Interactive comment on “

Towards a more representative parametrisation of hydrological models via synthesizing the strengths of particle swarm optimisation and robust parameter estimation” by T. Krauß and J. Cullmann

T. Krauß and J. Cullmann

Fig. 1. Figure 6a

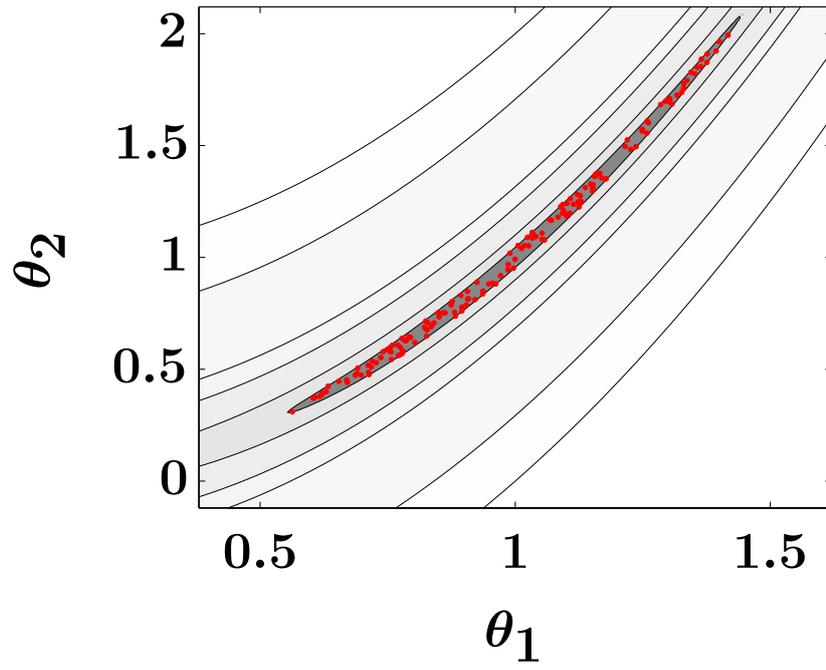
>PSO and other randomized search methods were not designed as uncertainty analysis methods. This means that >the vectors generated do not necessarily follow cover the space well and/or follow the prior distributions - which is >done by standard MC procedures. The objective of PSO and similar methods (like GA, ant colony optimization, >adaptive cluster covering, SCE-UA, AMALGAM, etc.) is to quickly move towards the global optimum, so that the >parameter space will not be thoroughly explored. There have been studies reported when such methods were >indeed used for uncertainty analysis as well, but there is of course no surprise they are more economical since >they are not geared towards exploration of parameter space. I would suggest providing some brief discussion on >this issue, or at least mentioning this. I would also suggest to provide references to the methods of “economical” >uncertainty analysis (sampling) that are combining ideas of on random search methods and MCMC

Metropolis algorithm (SCEM-UA, DREAM, etc) – see papers by Vrugt and co-authors.

We introduced a brief discussion on this issue into the introduction section. Furthermore we provide some results that support the ability of the developed PSO based approach PSO-GA_u for the estimation of good parameter vectors within a larger region. They are presented in the course of the presentation of this method. Please refer to Figure 6a) and b) on page 10. We attached these figures to this comment as well.
